# Inter-Office Memorandum

## GPU Service

Date: June 27, 1979  
TSG/253

Subject: RCS Pressure Indication

REACTOR COOLANT SYSTEM PRESSURE MEASUREMENT

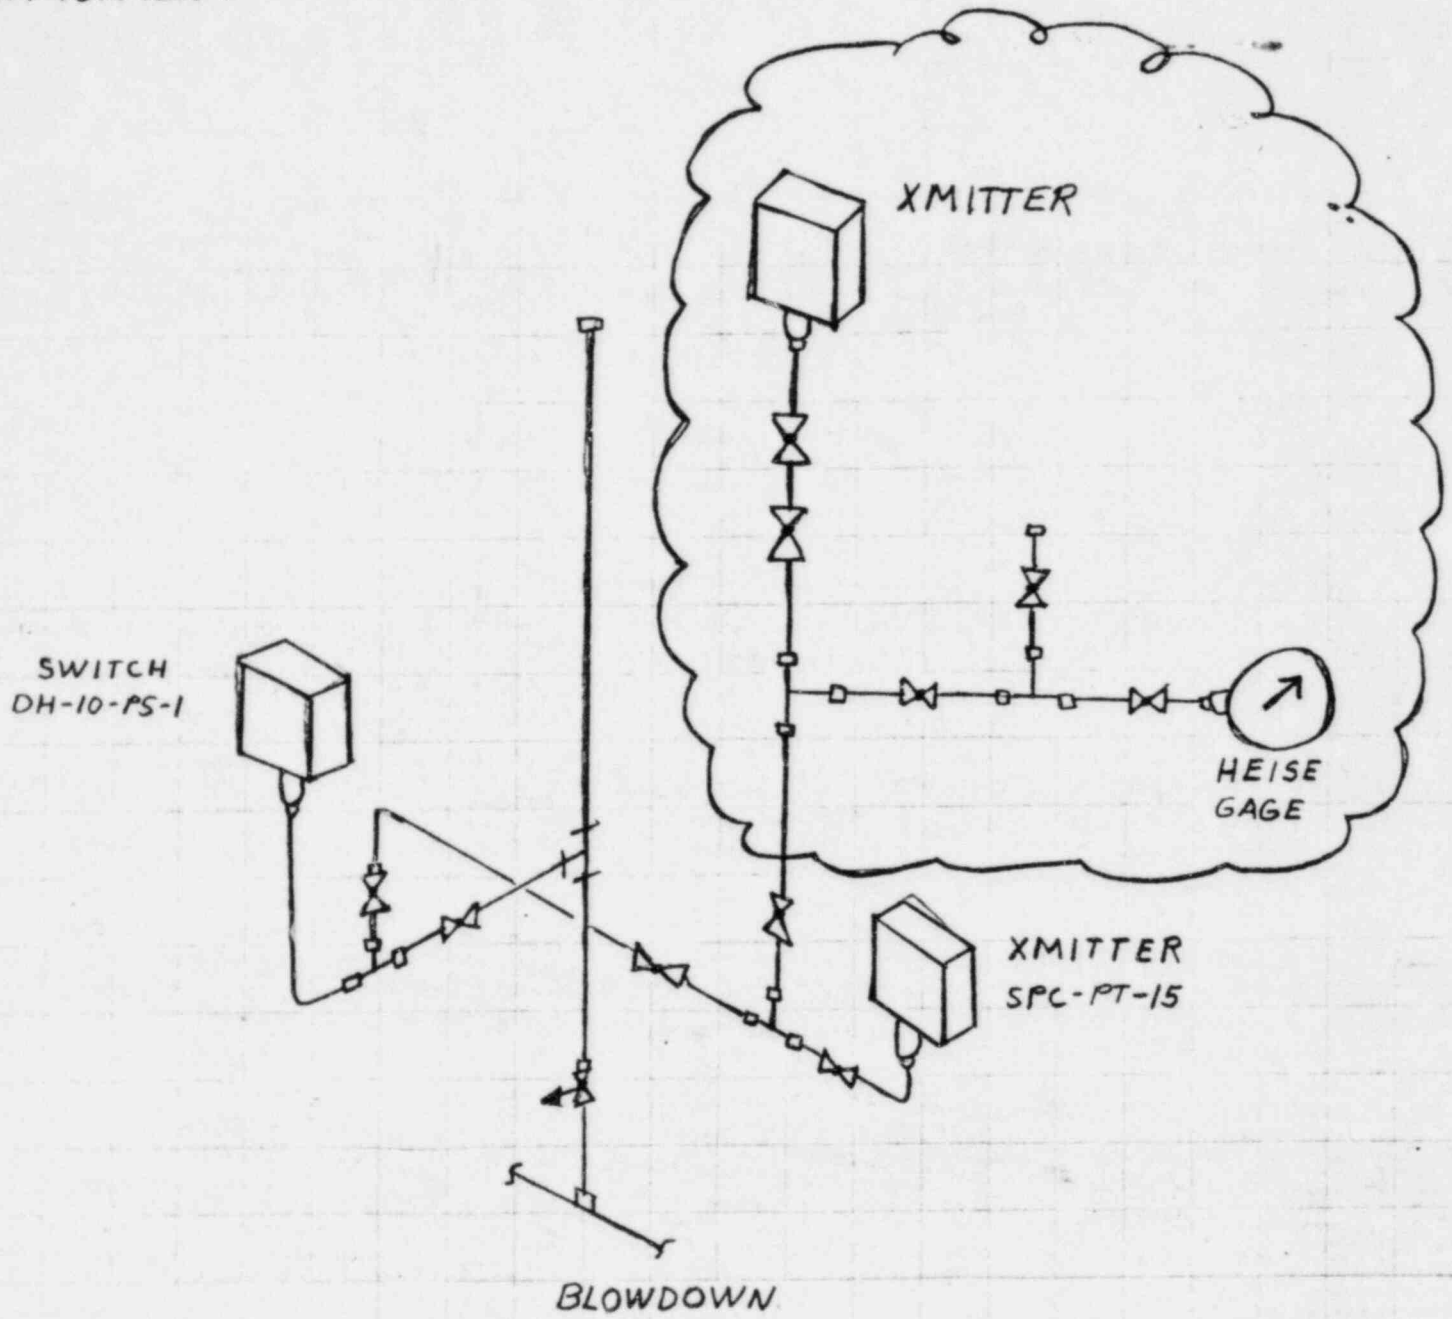
The attachment shows the existing instrumentation and the proposed instrumentation (clouded). The proposed instrumentation consists of an additional transmitter, a Heise gage, and the necessary piping and electrical connections. The transmitter can be connected to monitoring instrumentation in the control room by using existing cables or by running a new cable. The Heise gage should be located to minimize any radiation exposure to personnel.

The instrumentation in the decay heat removal system for monitoring RCS pressure is DH-10-PS-1 and SPC-PT-15. DH-10-PS-1 is a pressure switch used for an alarm. SPC-PT-15 is a transmitter used to provide the RCS pressure indication. Should SPC-PT-15 fail, the only alternate means of indicating RCS pressure would be the Heise gage at the sample sink. Consequently, there would be no available means of monitoring RCS pressure if a sample were being drawn or if the Heise gage failed. In order to rely less on the Heise gage at the sample sink, an additional transmitter and a Heise gage should be added to the instrumentation that is now on the decay heat removal system. This will provide redundant pressure indication should one transmitter malfunction and will provide a gage reading locally should both transmitters malfunction. It is recommended that the calibration range be 0-500 psig, thus providing narrow range indication and better resolution in the operating region (the existing transmitter is calibrated for 0-1000 psig).

Also included (see attachment) are double isolation valves to the redundant transmitter. This provides two valve protection to facilitate repair without complete loss of pressure indication. The piping configuration is such that two valve protection is also provided for the Heise gage; thus, it will allow removal of the Heise gage for calibration and/or repair while maintaining pressure indication with the transmitter.

A high degree of reliability, a means of comparison and necessary maintenance can be achieved by the proposed redundancy. In order to keep radiation exposure to a minimum, these additions should be made prior to opening either DHV171 or DHV1.
